RAI 03.07.02-24, Supplement 1, Revision 1**QUESTION:****Follow-up Question to RAI 03.07.02-15 (STP-NRC-100036)**

RAI 03.08.01-9, Revision 2**QUESTION:****Follow-up to Question 03.08.01-6**

RAI 03.08.04-17, Supplement 1**QUESTION:****Follow-up to Question 03.08.04-1 (RAI 2964)**

RAI 03.08.04-28, Revision 1**QUESTION:****Follow-up to Question 03.08.04-19**

Figure 03.08.04-32.1: Radial displacement measurement plan in drywell, suppression chamber, and lower drywell

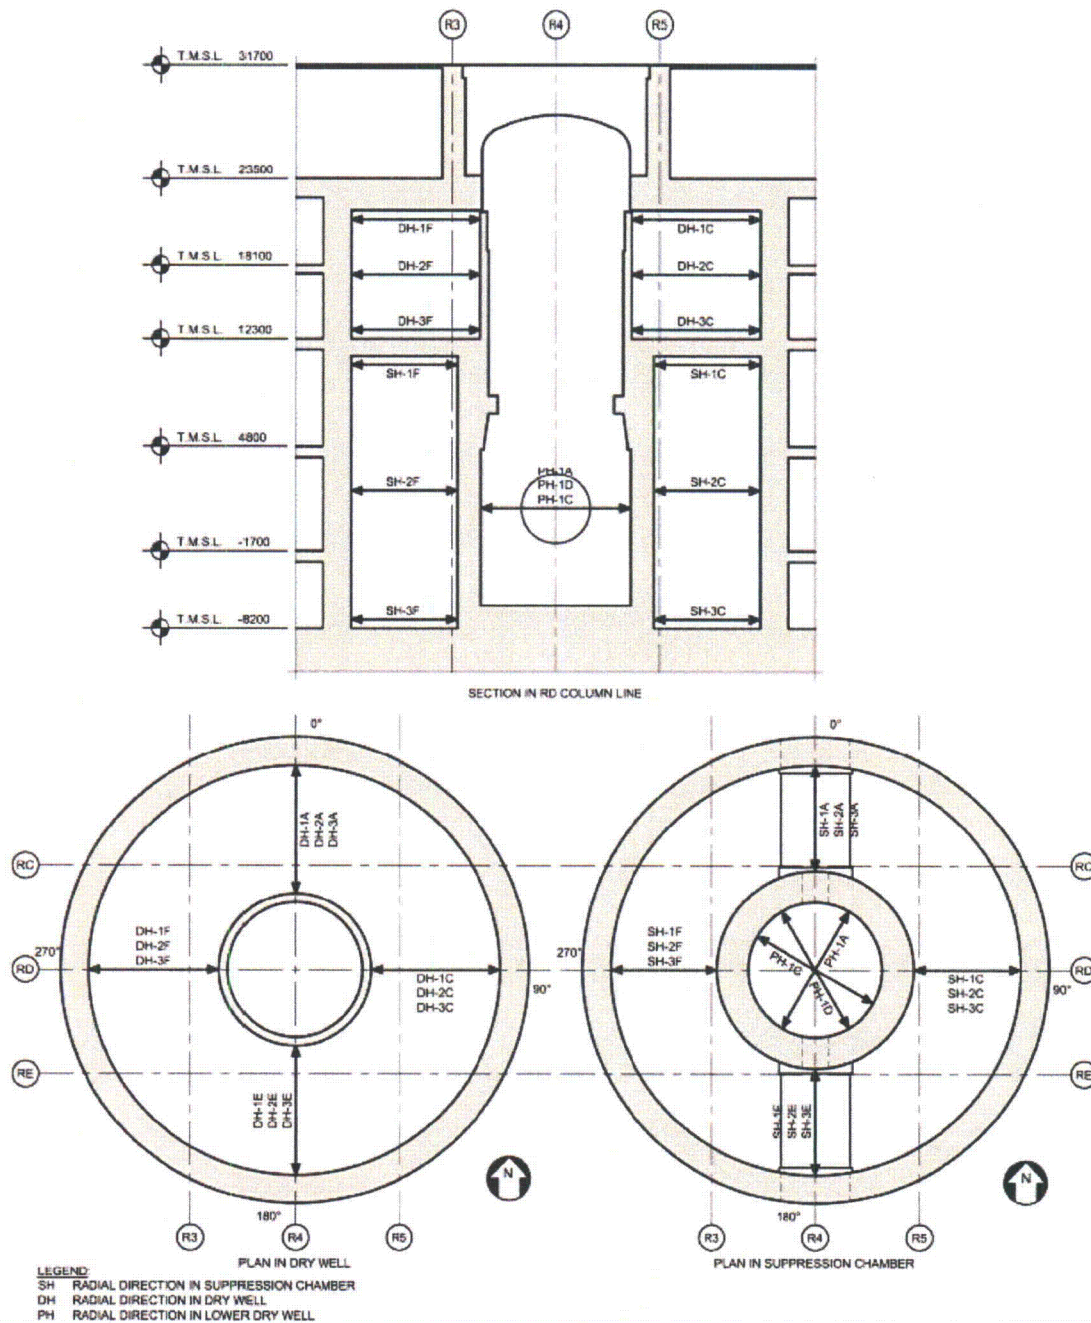
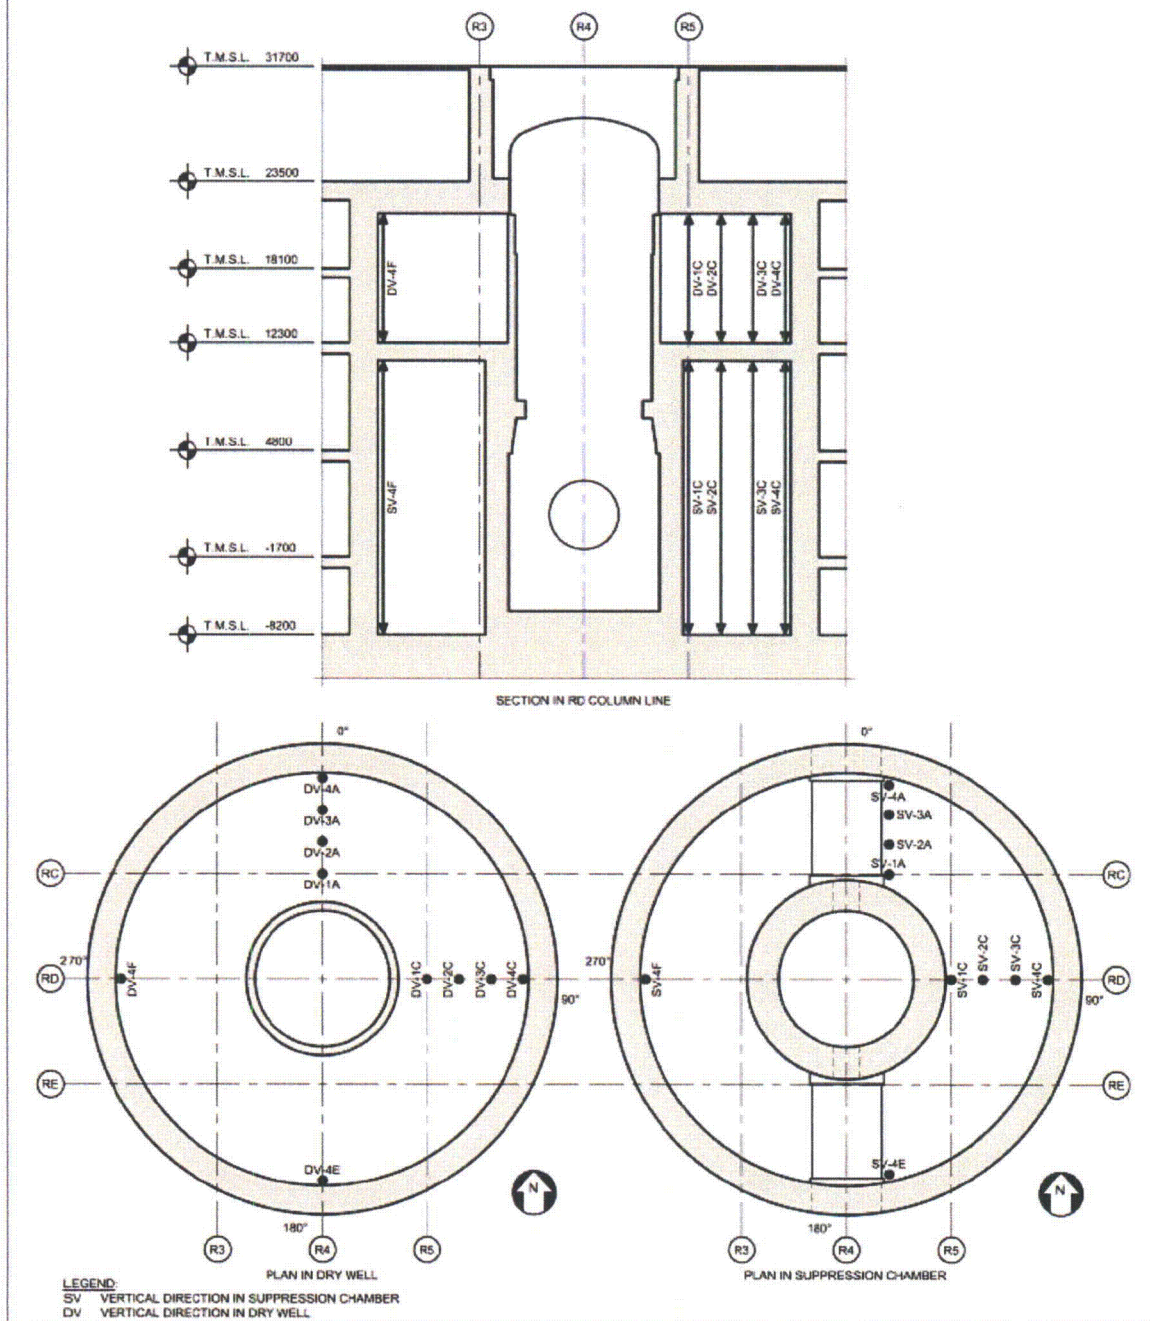
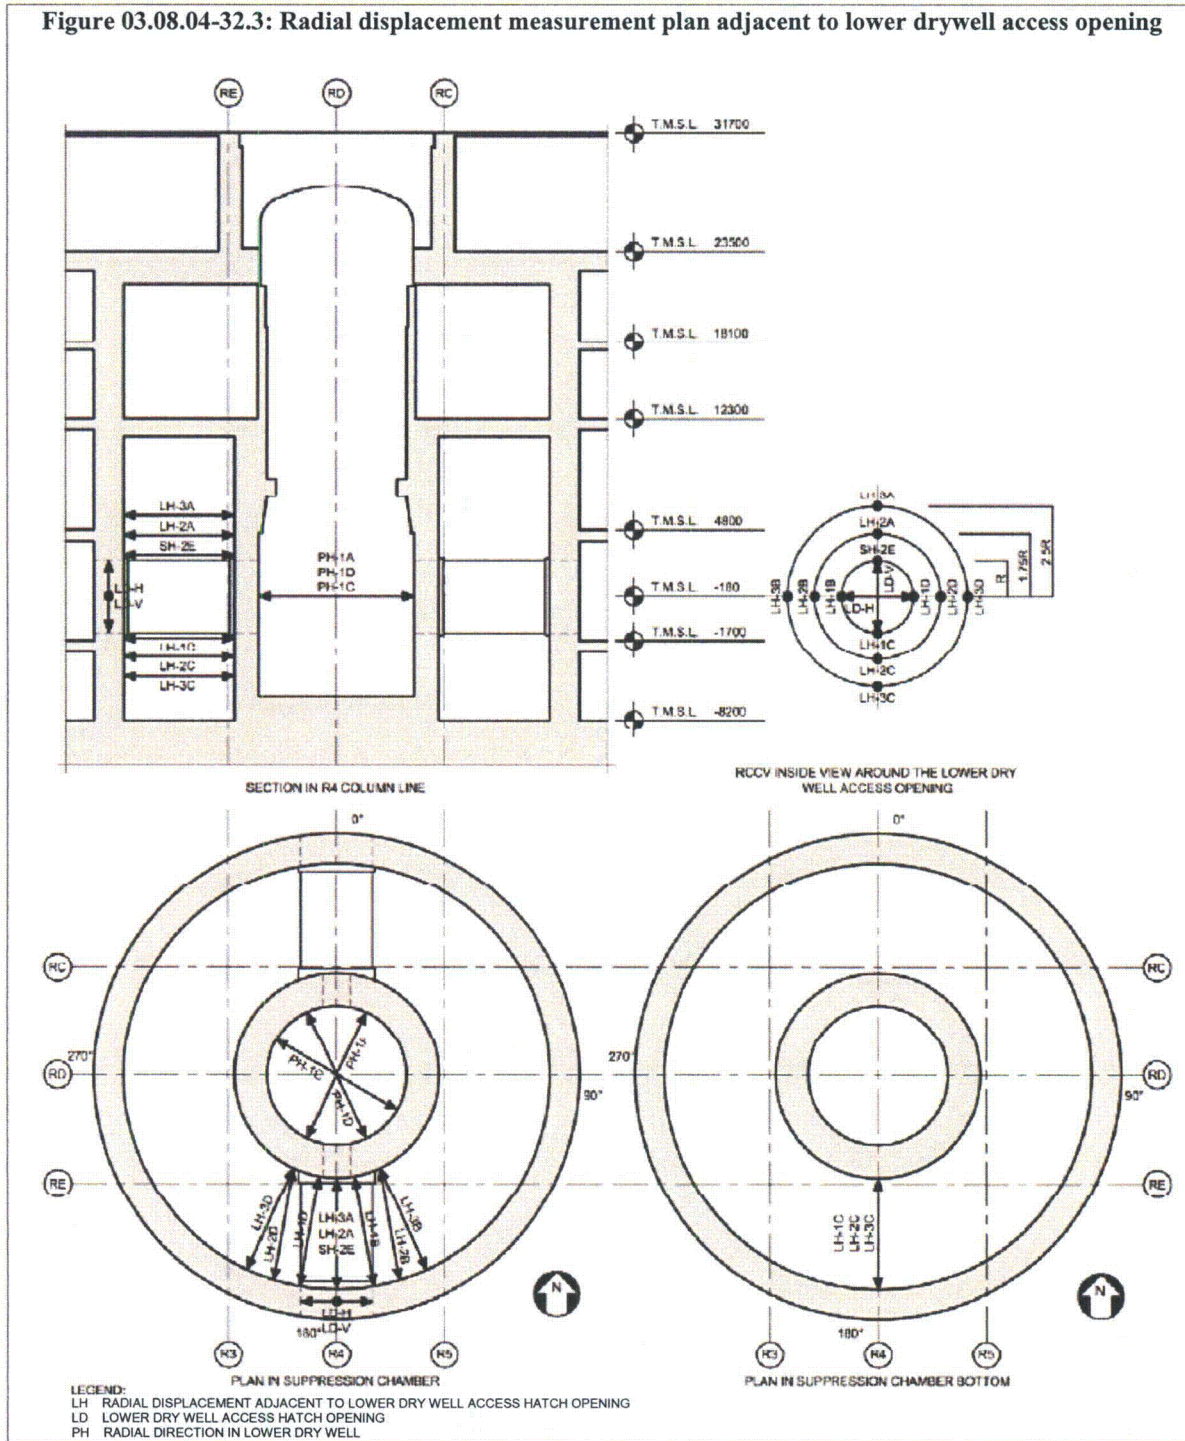
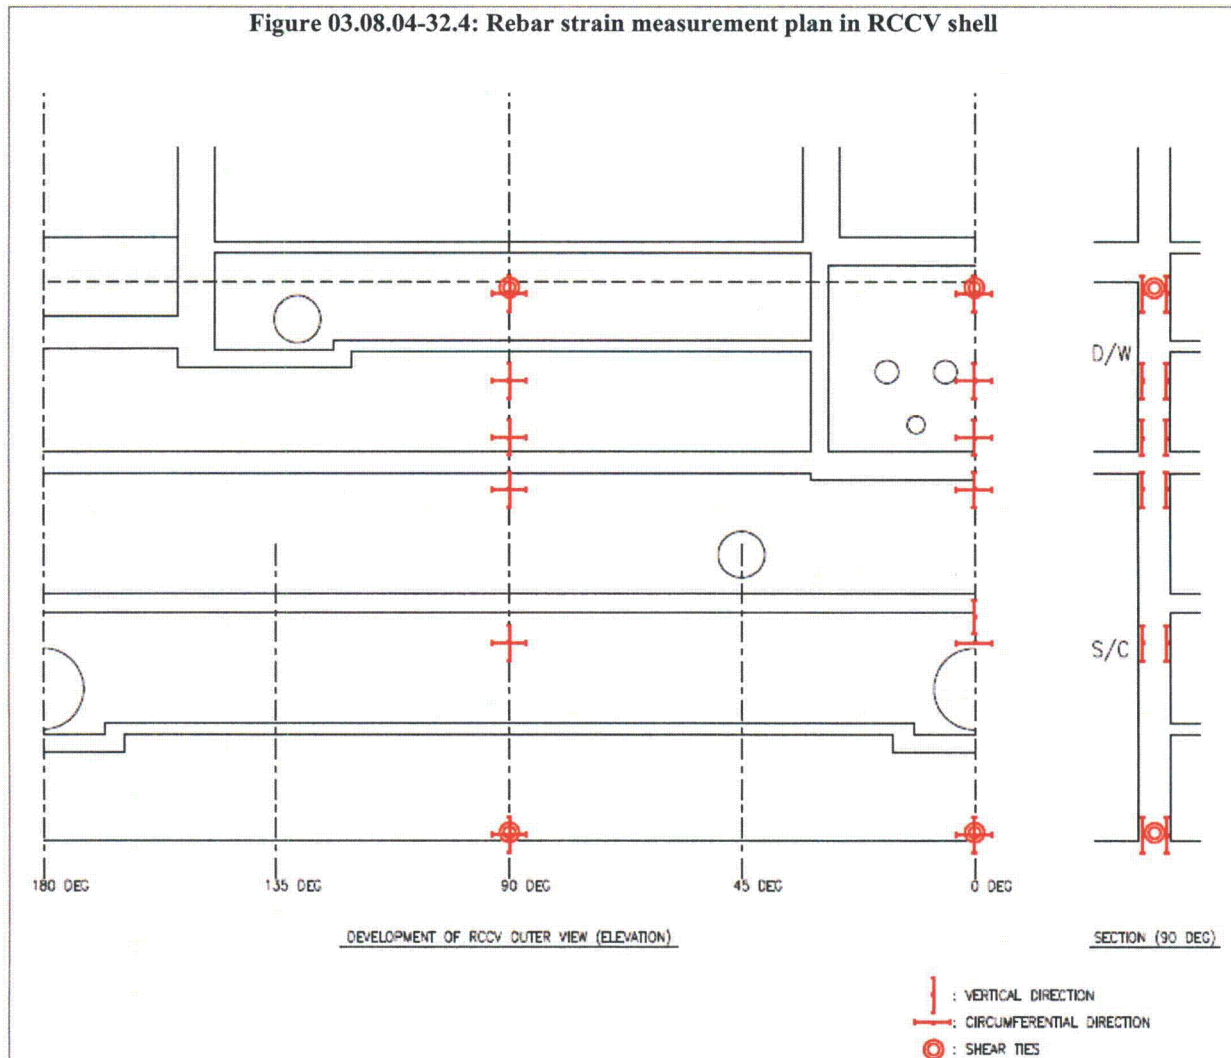
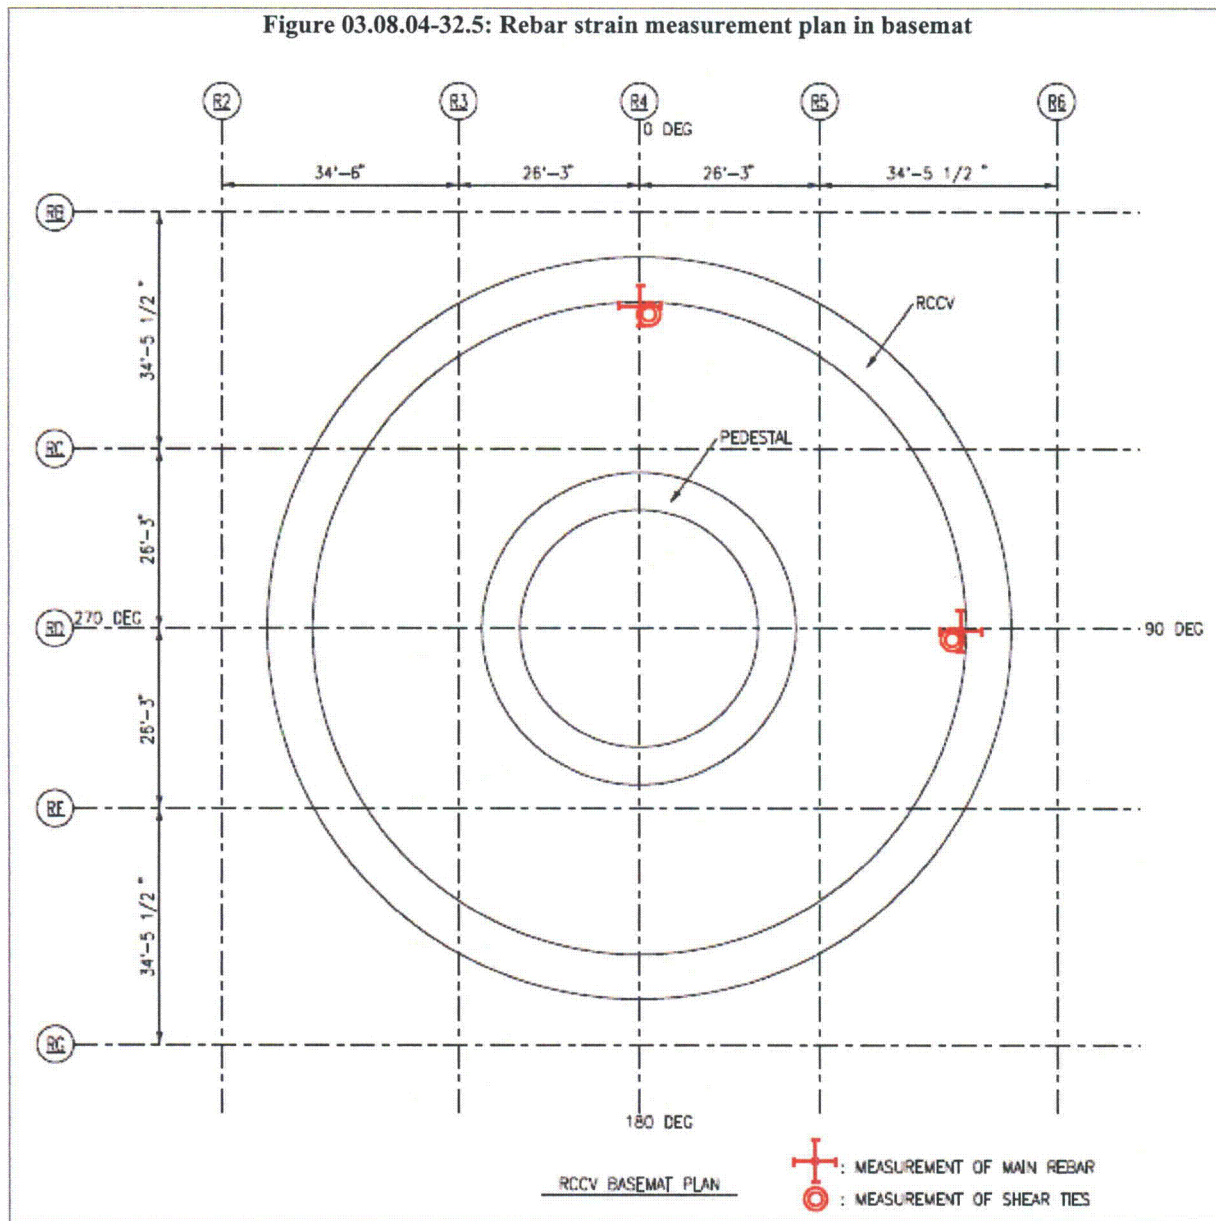
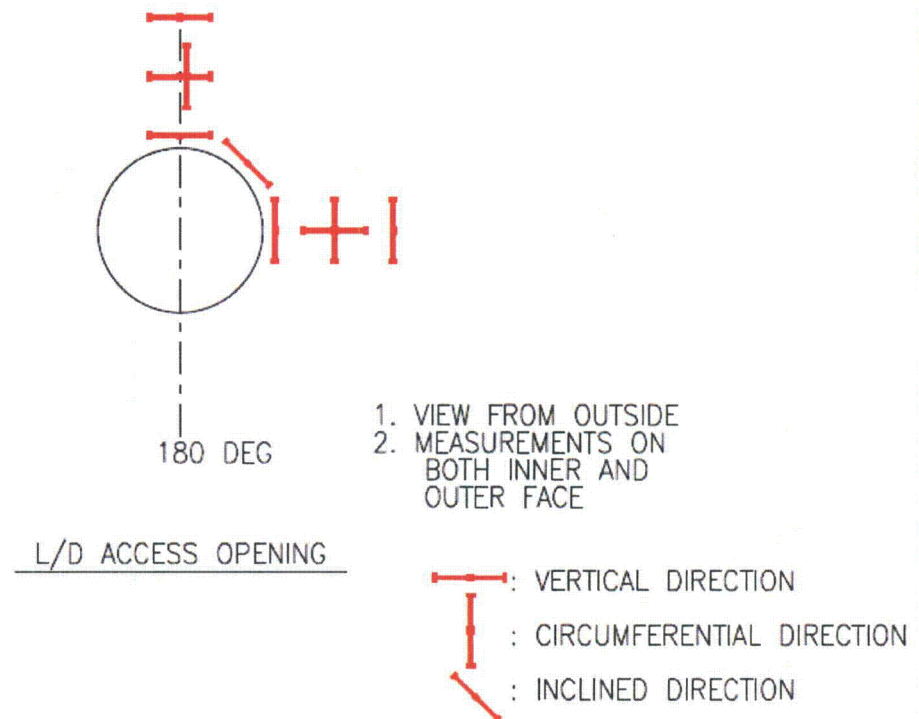
The applicant stated in its response (letter U7-C-STP-NRC-100036, dated February 10, 2010) to Question 03.08.04-27 regarding COL License Information Item 3.25 that the details of the Structural Integrity Test (SIT) and the instrumentation required for the test will be provided in the ASME Construction Specification. The applicant referred to RG 1.206, Section CIII.4.3, situation 4 for resolving the COL information item six months before performance of the test. According to RG 1.206, Section CIII.4.3, the applicant should justify why the item is not resolved before the issuance of license. However, the applicant did not provide any justification. Therefore, the applicant is requested to provide a detailed justification for why any part or all of the information pertaining to the COL information item cannot be provided at this time and clearly addressing all parts of COL license information item. Also, the applicant is requested to identify in Chapter 1 of the FSAR if the COL information item cannot be resolved completely before the COL is issued. The staff needs this information to conclude that deferral of the COL information item meets the guidance provided in RG 1.206.

The results of structural integrity tests will be submitted to the Designer. The report will meet the minimum requirements of CC-6530.
